### **TRANSMITTAL OF MEETING NOTES AND REVISED ADDENDUM 5 TO THE IMPACTED MATERIALS PLACEMENT PLAN FOR THE ON-SITE DISPOSAL FACILITY**

CONFERENCE/MEETING NOTES  
LETTER LOG NO.:MN:SWP(SDFP):2000-0057

SUBJECT: CATEGORY 3 ALTERNATE PLACEMENT

# CATEGORY 3 MATERIAL - ALTERNATIVE 2 - PLACEMENT SEQUENCE

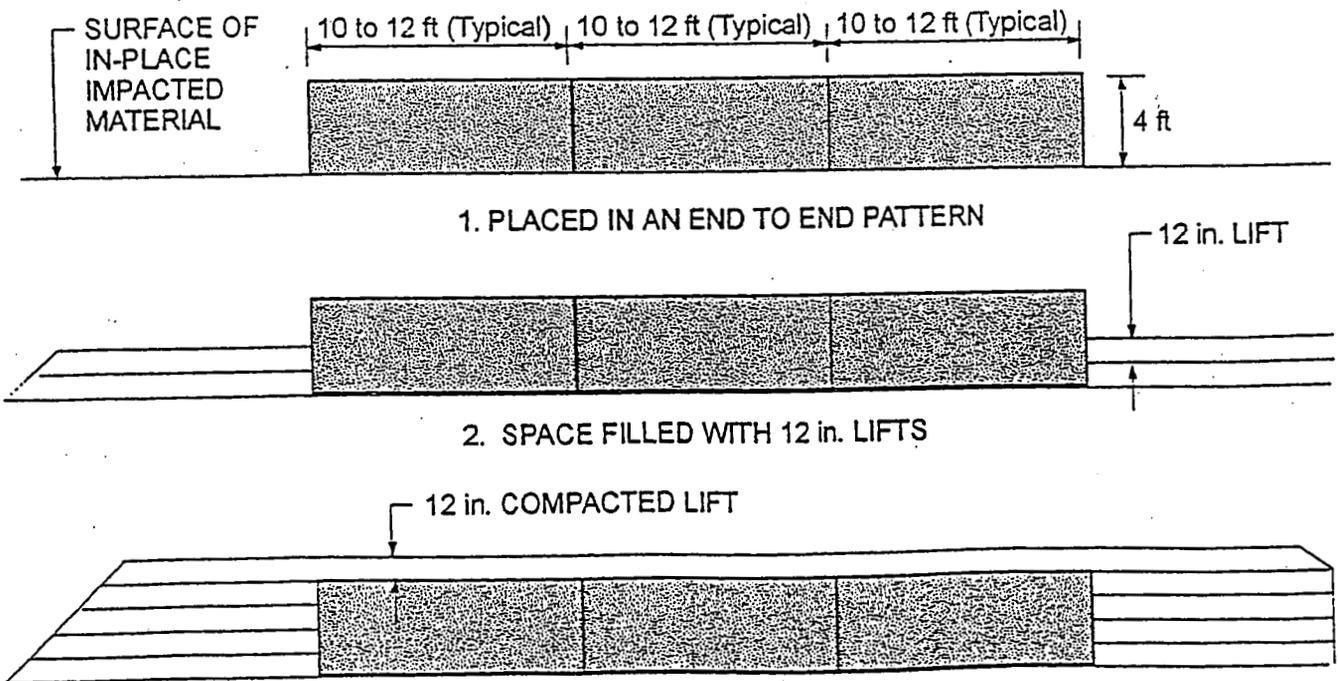
As shown in Figures 1 and 2 attached, the transite panel bundles were placed next to each other such that the interface between each bundle is aligned in an east-west direction. This orientation is recommended to eliminate a potential slip surface passing through a vertical interface between transite panel bundles. Furthermore, this orientation was selected with long-term stability being the primary consideration.

If transite panel bundles were placed with the interfaces aligned in a north-south direction, abutting bundles of transite panels could result in vertical interfaces with potentially low shear strengths. As transite panel bundles are placed in the On-Site Disposal Facility (OSDF), a series of these potentially low strength interfaces can occur at varying horizons of the placed impacted material. A long-term stability concern is that these interfaces could become interconnected to form a weak slip surface through the impacted material. Placement of transite panel bundles with interfaces aligned in the north-south direction is not recommended unless supported by stability analysis. The recommended east-west orientation described in the preceding paragraph eliminates the need to know the exact locations of the bundles at the outset of placement, or the need to conduct stability analyses during operation of the OSDF. Placement of transite panel bundles in any orientation is not recommended for the most northerly and southerly cells under long term conditions.

**CATEGORY 3 MATERIAL - ALTERNATIVE 1 - PLACEMENT SEQUENCE**

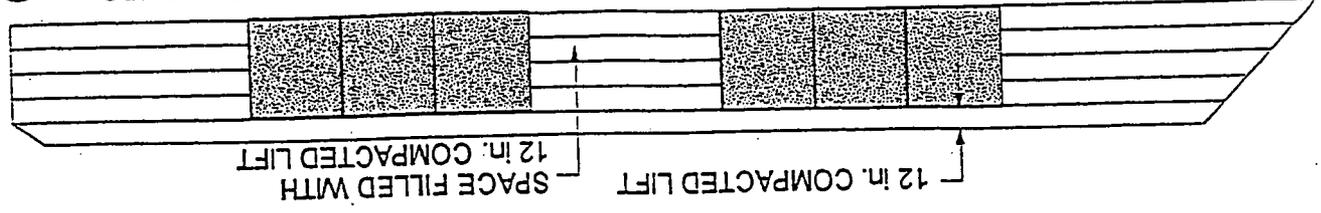
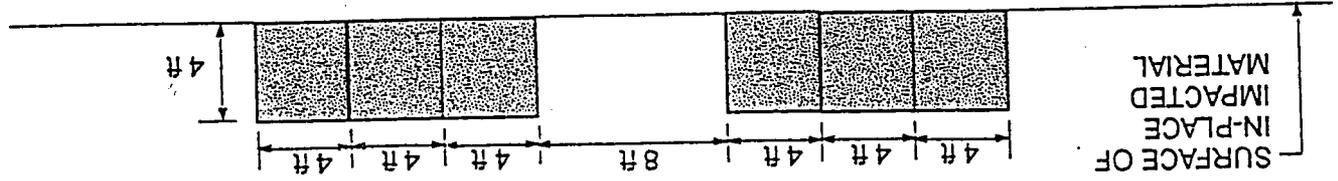
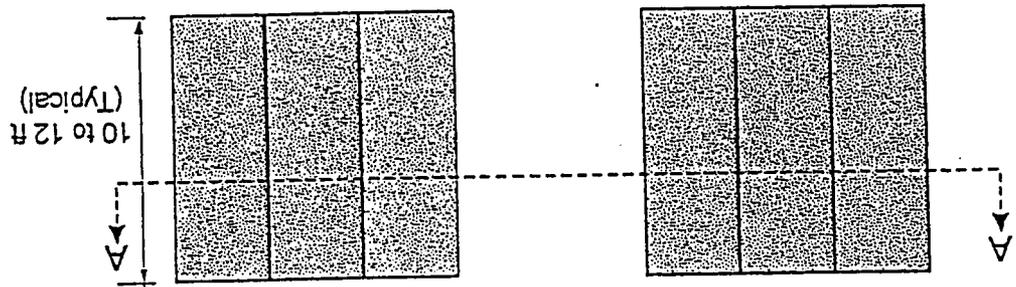
The proposed Addendum 5 states that space between the transite panel bundles shall not be more than 2 inches. The demonstration on May 16, 2000 showed the bundles can be placed directly adjacent to one another with little or no space between the bundles.
